SERVICE BULLETIN

TITLE: FUEL - INSPECTION/REPLACEMENT OF FUEL CELLS

Model G58 Baron, Serials TH-2356 through TH-2378.

Access Panel Locations
Figure 1

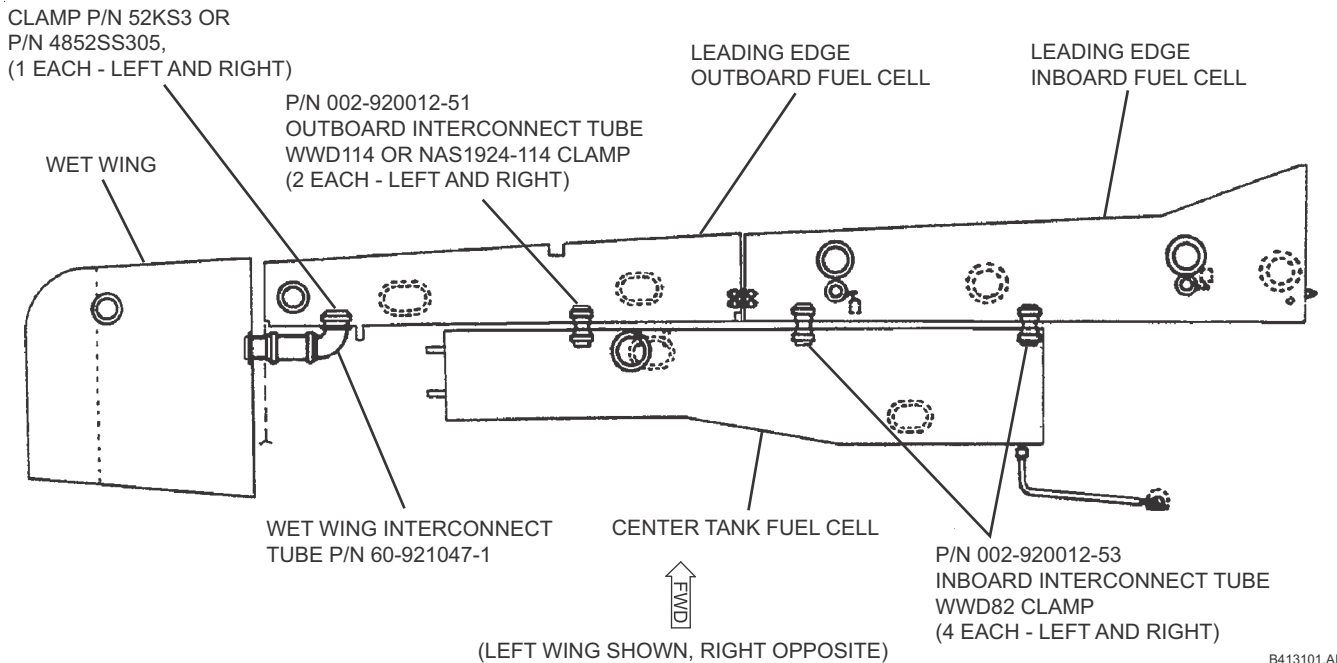
- (b) Defuel the airplane in accordance with the applicable chapter/section of the appropriate Maintenance Manual or Shop Manual.
 - (c) Remove lower and upper access panels to enable replacement of the inboard, outboard and center section fuel cells. Refer to Figure 1.

- (d) Remove the respective fuel cell doors to gain access to the fuel cells. These doors are located behind access panels removed in Step (1)(c).
 - (e) Remove the exhaust heat shields to enable access to fuel cells. Refer to Figure 1.

Fuel Cell Installation Requirements
Figure 3

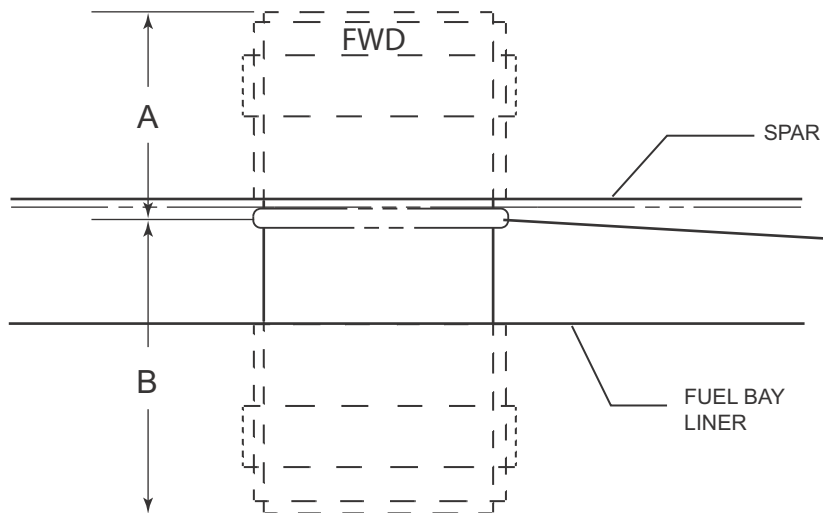
Verify interconnect tube position relative to the spar. If the interconnect tube is not correctly positioned, unintended loads could be induced on the fuel cell.

- (a) Apply forward pressure to the aft side of each interconnect tube. If the interconnect tube(s) are installed correctly the tube bead should come against the spar and not continue to the leading edge fuel cell area (Refer to Figure 3). If the interconnect tube is not installed correctly remove the interconnect tube and install correctly per Figure 3. If the tube is installed correctly proceed to the next step.

- (b) *The purpose of this step is to verify that the fuel cell is positioned tight against the spar. If the fuel cell is not tight against and supported by the spar, unintended loads could be induced on the fuel cell.* Hold forward pressure on the aft side of the interconnect tube(s), access the forward side of the interconnect tubes in the inboard and outboard leading edge fuel cells and ensure that the leading edge inboard and outboard fuel cells, at each interconnect tube, are tight against the forward side of the spar. If not tight, reposition nipple, ensuring it is tight against the forward face of the spar.

THE MIDDLE BEAD OF THE INTERCONNECT TUBE SHOULD BE ON THE AFT SIDE OF THE SPAR. THE INTERCONNECT TUBE SHOULD BE STICKING OUT OF THE NIPPLE ON BOTH SIDES FOR THE MID-BOARD AND INBOARD TUBES. THE OUTBOARD TUBE SHOULD BE FLUSH OR SLIGHTLY IN OR OUT DEPENDING ON TOLERANCES.

VIEW SHOWING THE MIDDLE BEAD OF THE P/N 002-920012-51 OR -53 INTERCONNECT TUBE LOCATED ON THE AFT SIDE OF THE SPAR.
